Re: Douglas Harbor POA-2000-495-M3 Response to DNR Request for Additional Information

The following is written to respond to the requests for additional information contained in the DNR Division of Coastal and Ocean Management letter dated January 7, 2010. Responses to the (15) inquiries are given following a brief summary of the history of the basin and an explanation of why dredging is required.

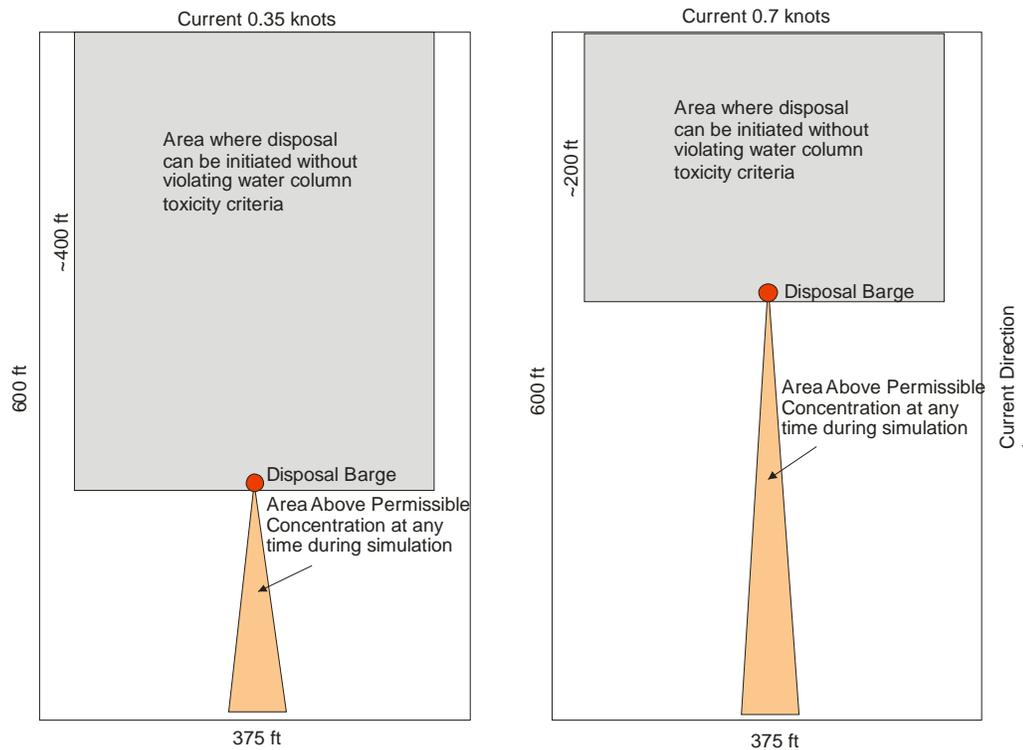
12. Provide information and a description of the expected duration of proposed deposit and the potential transport of pollutants by biological, physical, and chemical processes. Include consideration of the potential of propeller wash from cruise ships, current and tides to move the dredged material out of the disposal site and disperse the material over a larger area.

The ST Fate model used two current input velocities of 0.35 knots (0.59 feet per second) and 0.7 knots (1.18 feet per second) in the longitudinal direction of the disposal site. The slower velocity was selected because it corresponds to the most frequently occurring current (0.3-0.4 knots). Because the disposal site is so small the dump site was retained at the upcurrent end of the site under the assumption that disposal would be done at whichever end of the site was upcurrent at the time. The

figure below shows the area within the disposal site where disposal can be initiated without violating water column toxicity criteria under each current scenario.

This model output that the disposal of sediment into the Gastineau Channel disposal site is not expected to *release materials outside of the disposal site and based on the biological results the deposited material is not expected to cause adverse effects to water-column or sediment dwelling organisms living within the disposal site boundaries.*
